ENCLOSURE 1

PROPOSED TECHNICAL SPECIFICATION CHANGES
BROWNS FERRY NUCLEAR PLANT UNITS 1, 2, AND 3
(DOCKET NOS. 50-259, 50-26J, 50-296)

FIGURE 3.6-1

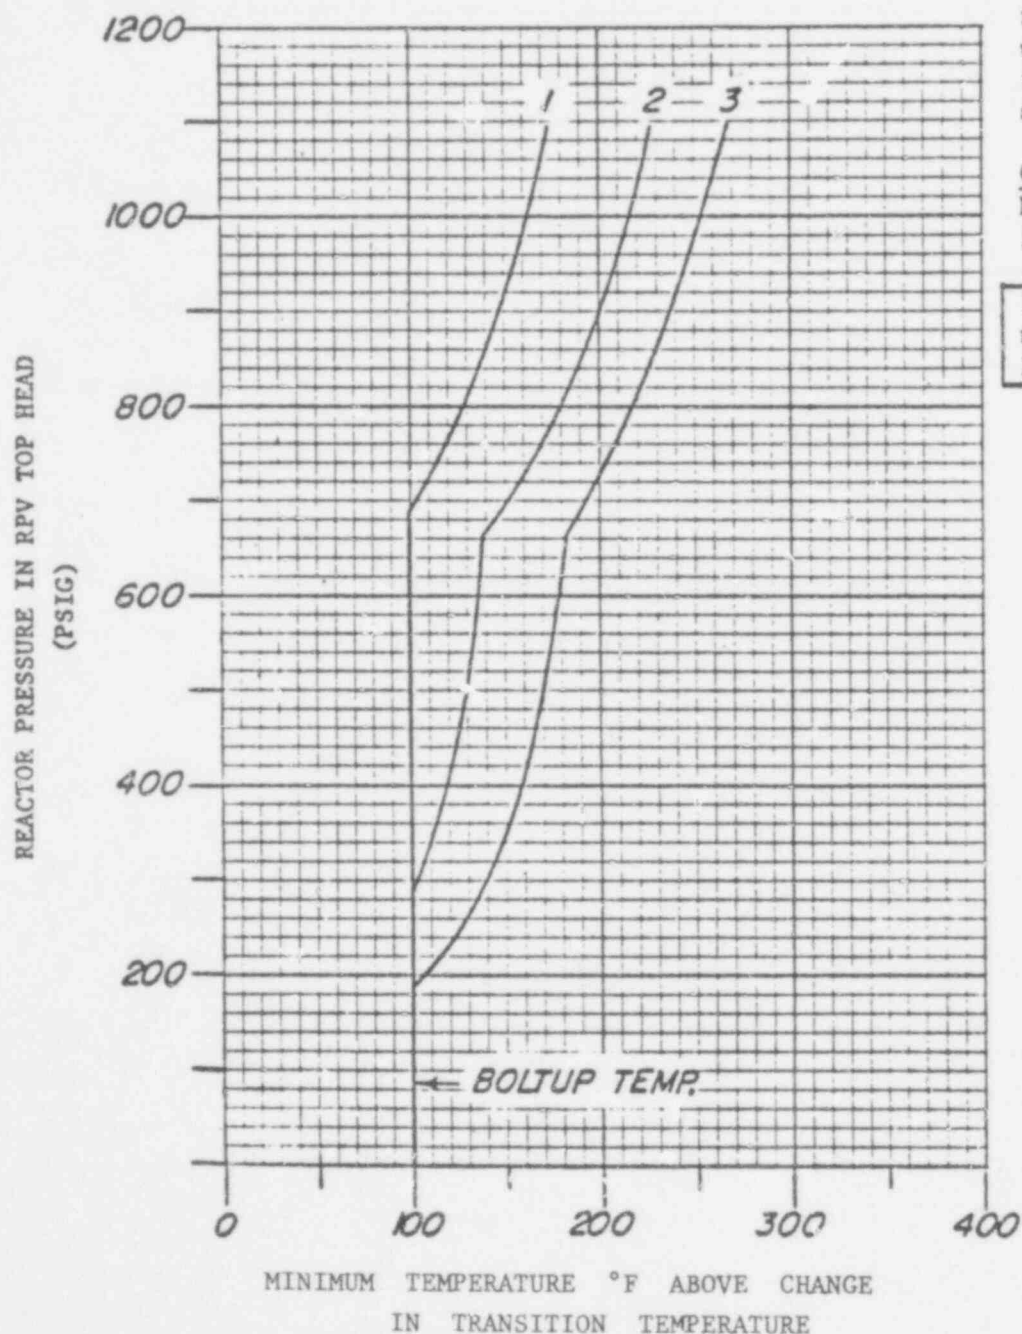
2. Proposed Revision to Figure 3.6-1

GE Topical Report NEDO-21778, "Transient Pressure Rises Affecting Fracture Toughness Requirements for Boiling Water Reactors," was prepared and submitted for NRC review to provide justification for modifying the requirements for the minimum permissible temperature of the reactor pressure vessel when the core is critical as set forth in paragraph IV.A.2.c of 10 CFR 50, Appendix G. In the topical report evaluation, provided as enclosure to letter from Olan D. Parr to Dr. G. G. Sherwood dated November 13, 1978, the NRC staff agreed with the requested deletion of the criticality limit based on the minimum permissible temperature for the inservice hydrotest. This revision will allow nuclear heat to be utilized above 100°F and will decrease vessel heatup time. NEDO-21778 and the topical report evaluation provide the necessary justification for this revision to Figure 3.6-1.

CURVE #1

Minimum temperature
for pressure tests
such as required by
Section XI

CURVE #2

Minimum temperature
for mechanical heat
up or cooldown
following nuclear
shutdown

CURVE #3

Minimum temperature
for core operation
(criticality)

[Includes additional
margin req'd by
10CFR50 Appendix G]
